CASE # V17-5210 Ross Bee Variance

Ross Bee, Applicant, JenkinsGavin Inc. Collen Gavin Agent, request a variance to the requirements set forth in the Sustainable Land Development Code (SLDC) of Chapter 7, Table 7-13: Rural Road Classification and Design Standards (SDA-2 and SDA-3) to allow an existing roadway to exceed 9% grade and a variance of Chapter 7, Section 7.17.9.2.4 to allow disturbance of 30% slopes in six separate areas.

ROSS BEE OFFSITE

PROPOSED ROADWAY PLAN AND PROFILE,

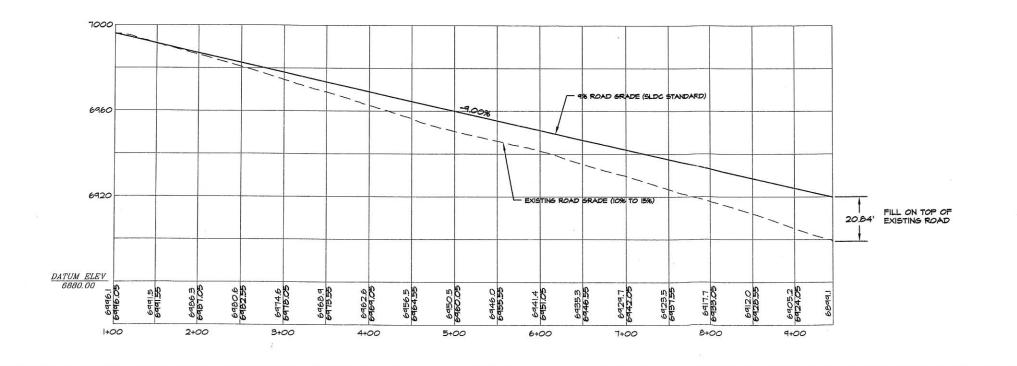
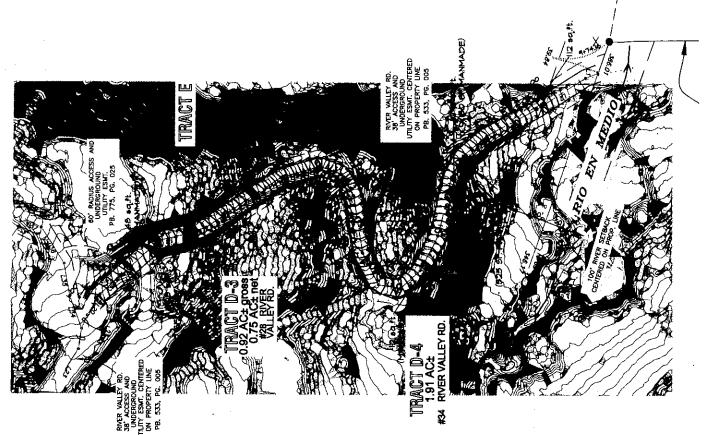
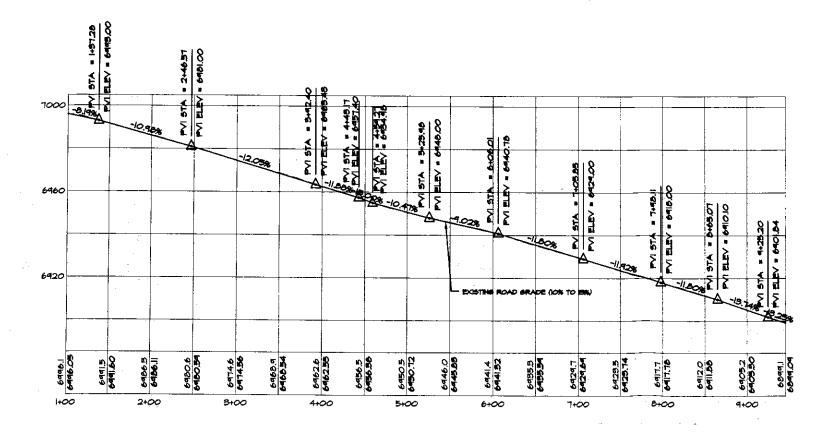
Staff Response: The Applicant's engineer has stated that the project will result in a total of 3,117 sq. ft. disturbance of slopes in excess of 30% and that most of these slopes are manmade as indicated in the Plan and Profile (Exhibit 4). The total amount of natural 30% slopes to be disturbed is 1,180 sq. ft., which will occur in (6) locations ranging in size form 22 sq. ft. to 468 sq. ft. (Exhibit 4). Chapter 7, Section 7.17.9.2.4: Utilities, drainage structures, slope retention structures, and access roads and driveways may be located on a natural slope in excess of thirty percent (30%) so long as they disturb no more than three separate areas not exceeding 1,000 square feet each. Staff acknowledges that the SLDC states three allotted disturbances of 1000 square feet per disturbance (3000 square feet total.) However, staff agrees that the total square footage of the six disturbances falls under 3000 square feet.

Staff Response: Staff acknowledges that River Valley Rd. has been in existence since November 20, 1963 (plat book 197 page 9.) Staff conducted a site visit and reviewed the Plan and Profile submitted by applicant and has confirmed that a portion of River Valley Road would need to be widened to (20) ft. in order to meet SLDC requirements. In order for the applicant to meet the (20) ft. driving surface, the applicant would need to disturb the exiting terrain, which has existing (30%) slopes. The applicant's engineer has stated that the project will result in a total of 3,117 sq. ft. disturbance of slopes in excess of 30%. Ten of these slopes are manmade as indicated in the Plan and Profile (Exhibit 4). The total amount of natural 30% slopes to be disturbed is 1,180 sq. ft., which will occur in (6) locations ranging in size form 22 sq. ft. to 468 sq. ft. (Exhibit 4). Plat book 672 page 45-46 indicates River Valley Rd. has a (38) ft. access, which meets current SLDC requirements.

Staff Response: Chapter 7, Section 7.17.9.2.4: Utilities, drainage structures, slope retention structures, and access roads and driveways may be located on a natural slope in excess of thirty percent (30%) so long as they disturb no more than three separate areas not exceeding 1,000 square feet each. The SLDC requires two (10) ft. driving lanes with a (38) ft. ROW with a max grade of (9%). After review of Applicant's Plan and Profile, the number of disturbances exceeds the SLDC requirements. However, the total square footage of natural 30% slope disturbed areas is less than the total square footage of 3,000 square feet as defined in the SLDC.

The Applicant did provide responses to the variance review criteria. Staff recommends approval of a variance from Ordinance No. 2016-9 the Sustainable Land Development Code (SLDC) of Chapter 7, Table 7-13, Rural Road Classification and Design Standards (SDA-2 and SDA-3) to allow an existing roadway to exceed 9% grade and Chapter 7, Section 7.17.9.2.4 to allow disturbance of 30% slopes in six separate areas.
